**MINERALS PROGRAM INSPECTION REPORT**  
**PHONE: (303) 866-3567**

<b>MINE NAME:</b> Cresson Project	<b>MINE/PROSPECTING ID#:</b> M-1980-244	<b>MINERAL:</b> Gold	<b>COUNTY:</b> Teller
<b>INSPECTION TYPE:</b> Monitoring	<b>INSPECTOR(S):</b> Timothy Cazier	<b>INSP. DATE:</b> January 28, 2020	<b>INSP. TIME:</b> 10:00
<b>OPERATOR:</b> Cripple Creek & Victor Gold Mining Company	<b>OPERATOR REPRESENTATIVE:</b> Justin Bills, Katie Blake	<b>TYPE OF OPERATION:</b> 112d-3 - Designated Mining Operation	
<b>REASON FOR INSPECTION:</b> Normal I&E Program	<b>BOND CALCULATION TYPE:</b> None	<b>BOND AMOUNT:</b> \$209,491,188.00	
<b>DATE OF COMPLAINT:</b> NA	<b>POST INSP. CONTACTS:</b> None	<b>JOINT INSP. AGENCY:</b> None	
<b>WEATHER:</b> Clear	<b>INSPECTOR'S SIGNATURE:</b> 	<b>SIGNATURE DATE:</b> February 12, 2020

Photo 3. VLF2 from VLF1 overlook – no ponded process solution observed (note flattened slope).

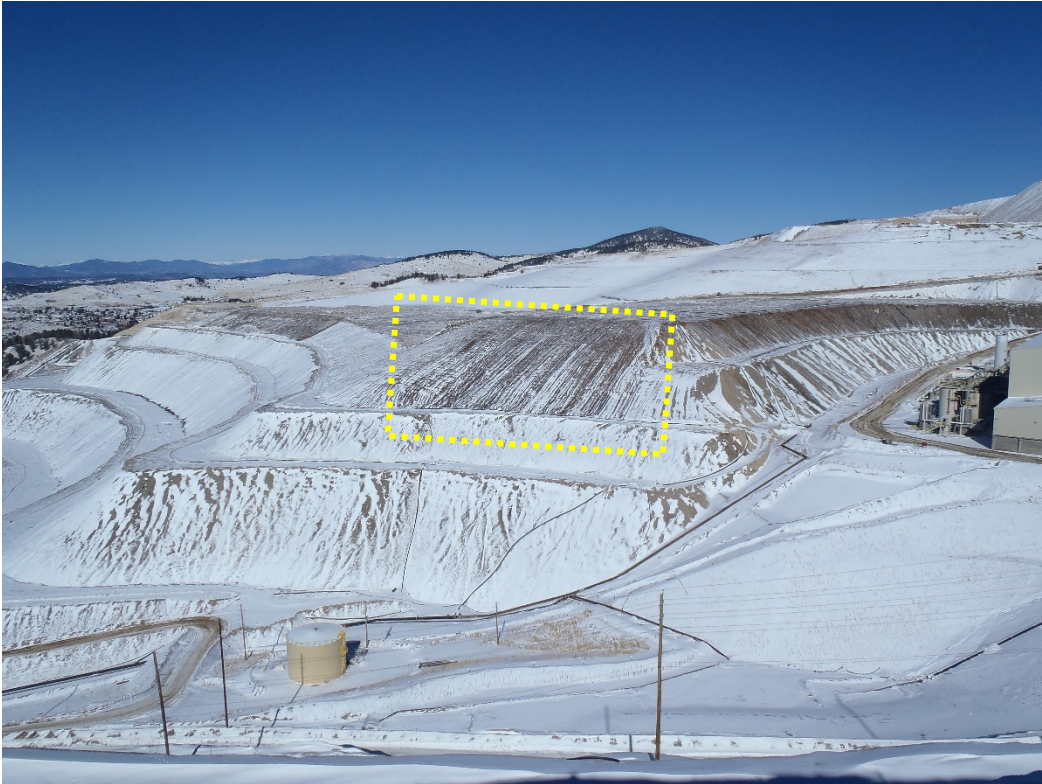
Squaw Gulch Valley Leach Facility (VLF2): Messrs. Bissue, Noble and Laurin Colby accompanied the DRMS to the VLF 2 overlook (from VLF 1). Snow was observed on the outcrops of VLF2, but the top was relatively clear and no ponded process solution was observed (see **Photo 3**).

Photo 4. HJ-8 injection well on 9925 bench of VLF1 (looking NW).

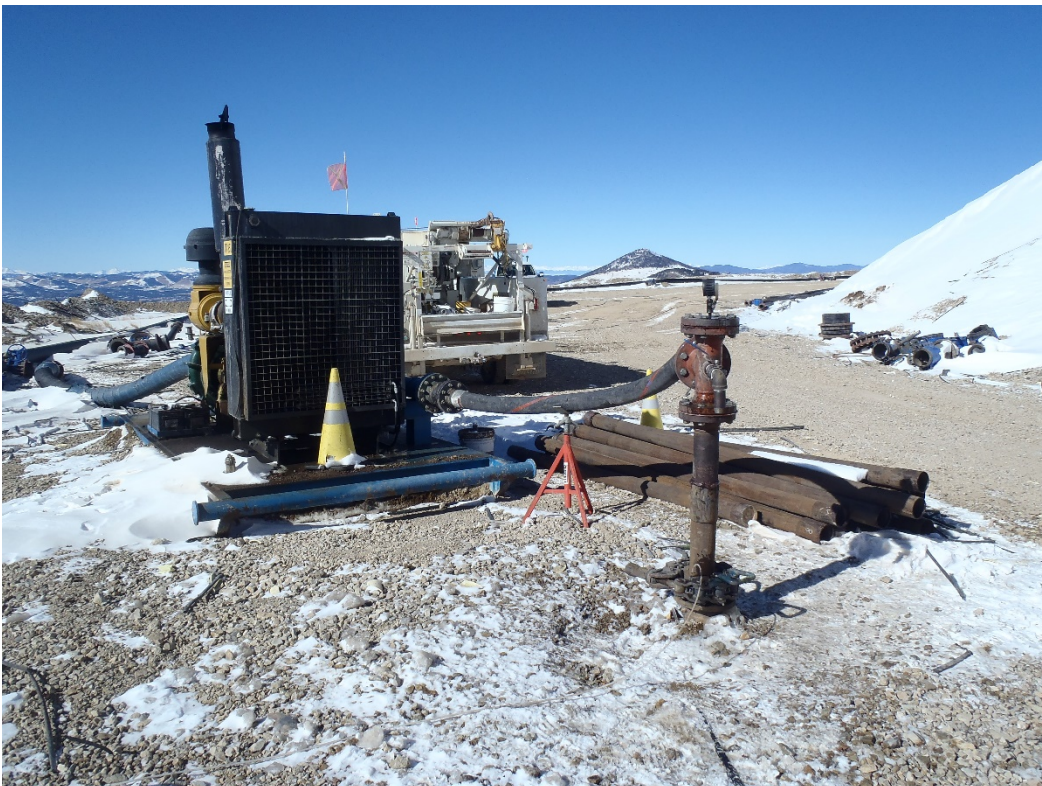
Arequa Gulch Valley Leach Facility (VLF1): Messrs. Bissue, Noble and Colby accompanied the DRMS to VLF 1 where the focus was on the operation of the injection wells approved with TR-57. Nine injection wells were constructed on the 9,925 level bench for the purpose of injecting lime at depth in VLF1. Well HJ-8 (see **Photo 4**) was being operated at the time of the inspection, but for process solution injection, rather than for lime. Site representatives explained only one well in an area contributing to a process solution storage area (PSSA "pond") is used for injection at one time and at no more than 1,600 gpm so as not to overwhelm the pumping capacity of the PSSA pumps. Site representatives explained the injection wells had perforations (approximately 1 inch in diameter) cut into the casing internally after it was set over a hundred or more feet, depending on the well. However, the specific injection interval is set to five feet by setting inflatable packers (pressurized to 300 psi and monitored). Well HJ-8 was being injected at a depth of 115 ft bgs at operated at a pressure of about 112 psi as indicated by the pressure gage (see **Photo 5**). The well operator explained the injection is limited by both pressure and flow rate, so as not to exceed either. Furthermore, the injection pressure at the injection depth is not to exceed the estimated lithostatic overburden pressure determined by HydroGeophysics in 2010 as part of the TR-57 pilot project. According to the HydroGeophysics determination, the estimated overburden pressure at 115 feet bgs is approximately 90 psi. The HydroJex pilot program measured the pressure at both the top of the well head and in the injection zone, within the casing. Due in part to the high flow rate (up to 1600 gpm) in a small pipe (three inch diameter), significant pressure/head loss was measured at the injection depth. As such, the pressure at the top of the well greatly exceeds that in the injection zone. Based on formulae developed from the pilot program data, the maximum top of well pressure (including a factor of safety) for an injection

depth of 110 feet is 119 psi. Therefore, the observed operating pressure was below the limit for the injection depth. It should be noted the DRMS is reviewing the February 10, 2020 adequacy response to the DRMS and additional information may be required.

Photo 7. January 24, 2020 aerial view of VLF2 ore stacking.

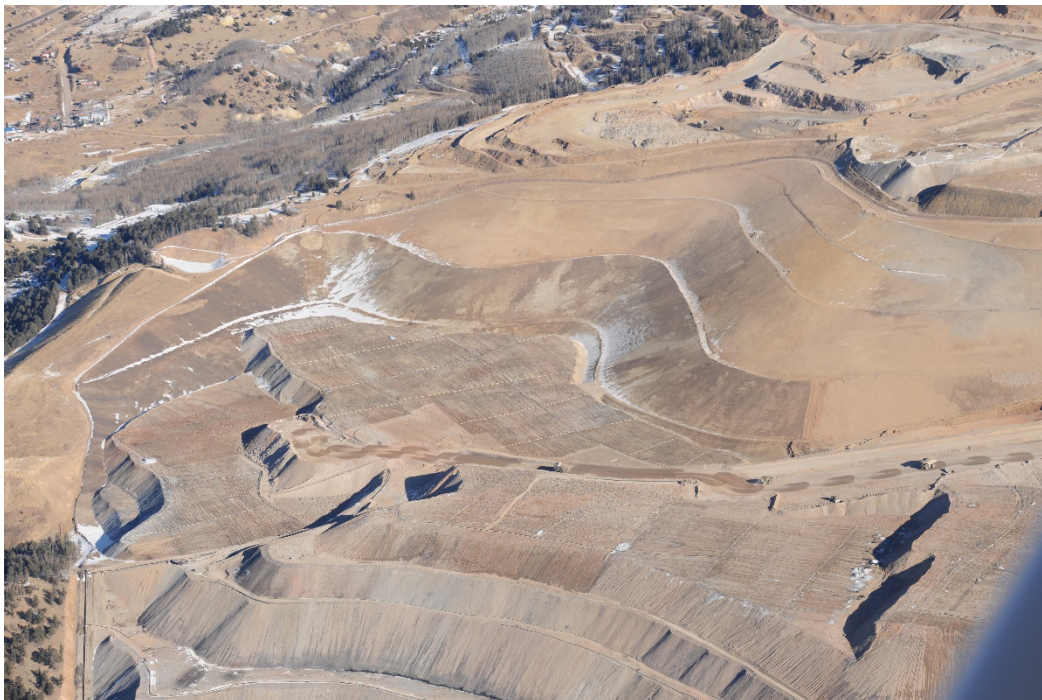
General Site Observations: The DRMS performed an aerial inspection on January 24, 2020 (see separate aerial inspection report). Photos from this aerial inspection were reviewed to determine if appropriate ore stacking practices were being adhered to on VLF2 (see **Photo 6**).
